Product Change Notification

1. ECN #: 242713

- TFM - .050 X .050 MICRO STRIPS

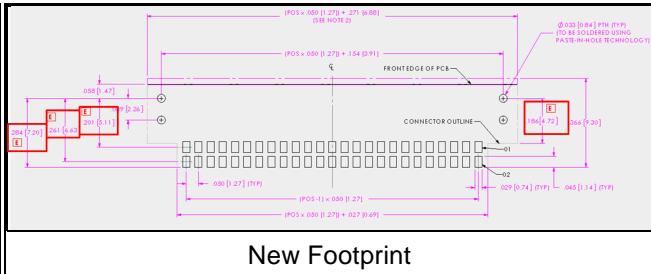
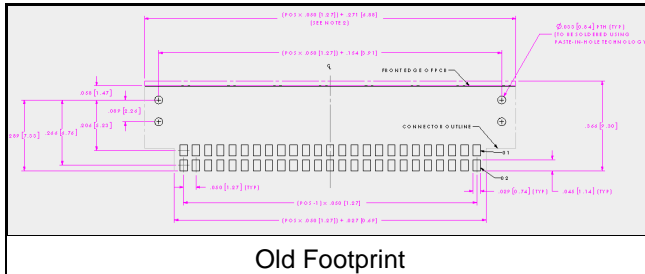
Updating the footprint layout to provide better part pin/leads to contact pad alignment.

The product design remains unchanged. The pad layout/footprint has been updated.

Provides better alignment of part leads to contact pad layout on mating PCB.

- Fit - Pad locations in reference to signal pin locations have been updated to better match the product.
